Work Order Number: 2023-18039

Work Pack Reference: 9M-BOE-18039

A/C Registration / SN: 9M-BOE/49045

Reference:	342-49-047 – SERVICE BULLETIN
Title:	Update of gas generator configuration
Issue number:	001
Issue Date:	27-apr-2023

Figure 3 : Update of Gas Generator Log Book to be implemented

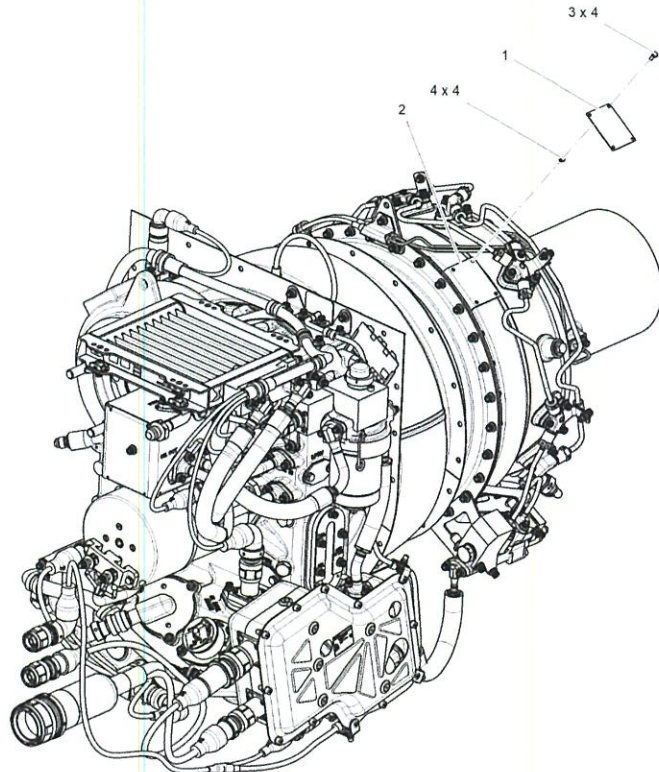
3.2. Remove and discard the four nuts (Figure 3, 4) and the four screws (3) that attach the identification plate (1) to the identification plate holder (2).

3.3. Discard the identification plate (1).
